UNITED STATES PATENT AND TRADEMARK OFFICE

10/586,195

David Bottomley

<i>Office Action Summary</i>	Application No.	Applicant(s)	
	10/586,195	BOTTOMLEY ET AL.	
	Examiner	Art Unit	
	ERNESTO GARCIA	3679

FIG 3

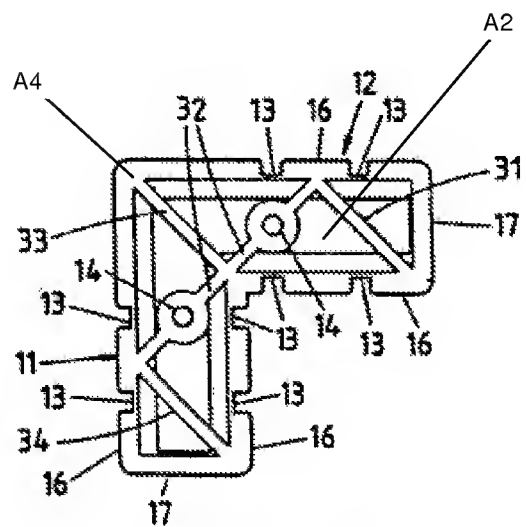
Regarding claim 1, Murphy et al. discloses, in Figure 3, a bracket comprising a body portion A1 (see marked-up attachment) and one or more arm portions 17 extending from the body portion A1. The arm portions 17 include at least one pair of parallel grooves 13 and at least one recessed region A2. Applicants should note that the parallel grooves 13 can be adapted to releasably engage complementary lips of the strut and the recessed region A2 can be adapted to securely engage one or more crimped portions of a strut.

Regarding claims 2 and 3, the grooves 13 and the recessed region A2 are arranged.

Regarding claim 4, the body portion comprises an upper face A3, lower face A4, and side faces A5.
